**Revised STAFF REPORT AND RECOMMENDATION  
 TO THE DESIGN COMMISSION**

**CASE FILE:** LU 15-195830 DZM  
 Blocks 294E/295E  
 (PC # 14-247472)  
**REVIEW BY:** Design Commission  
**WHEN:** November 5, 2015 @ 1:30pm  
**WHERE:** 1900 SW Fourth Ave., Room 2500A  
 Portland, OR 97201

NORTH FACADE DETAIL

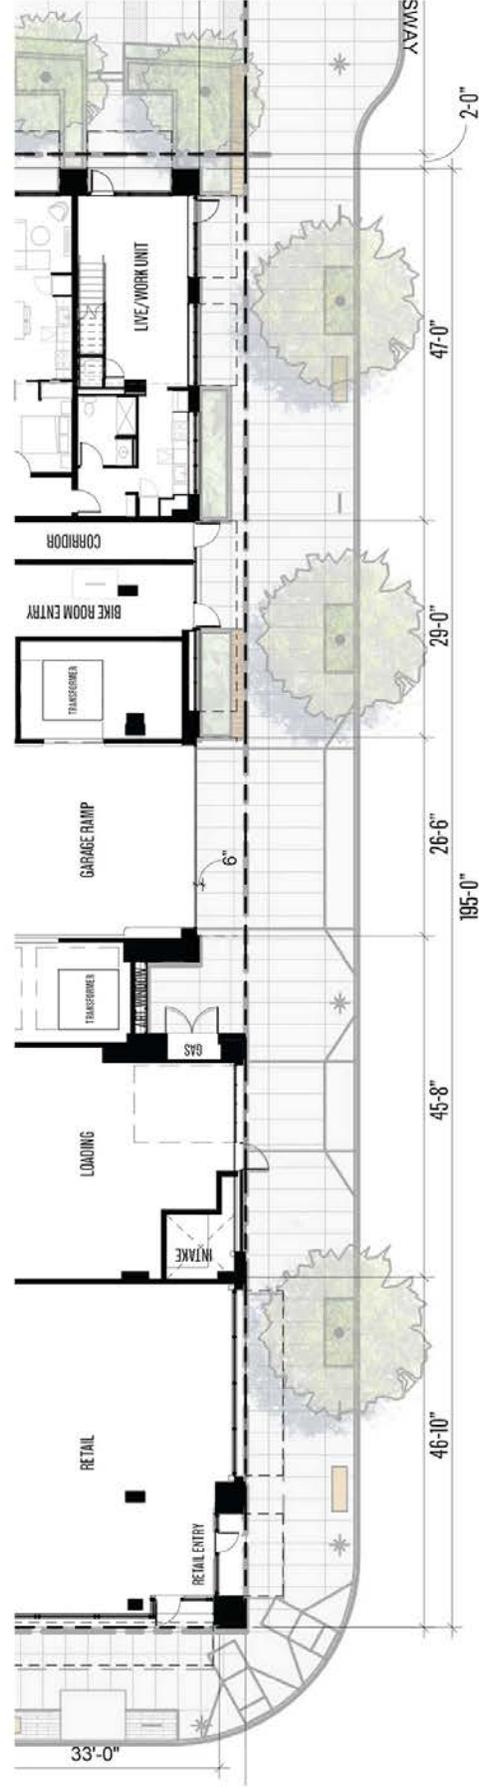
Staff has previously noted that the applicant has revised the northwest corner of Block 294E to include a true live/work unit with full-height windows and a door facing NW Thurman. Staff notes, however that the third bay from the west at this unit breaks the general window pattern of the building by proposing two tripartite windows with a brick spandrel between; this is inconsistent with the building's general pattern of large window expanses, which consistently extend the height of two floors. The proposed windows in this bay are the only instance in the entire building of window openings spanning only one floor. As such, staff has suggested a condition of approval that the third window bay from the west at the Thurman Street ground level be combined with a glass spandrel, rather than brick, between the tripartite windows.

*With the following conditions of approval, this guideline is met:  
The fabric awnings of Block 294E shall be revised to steel canopies, consistent with other steel canopies on the building; and  
The third window bay from the west at the Thurman Street ground level shall be combined with a glass spandrel, rather than brick, between the tripartite windows.*

| <p>B. The fabric awnings of Block 294E shall be revised to steel canopies, consistent with other steel canopies on the building.</p> <p>C. The third window bay from the west at the Thurman Street ground level shall be combined with a glass spandrel, rather than brick, between the tripartite windows.</p> |
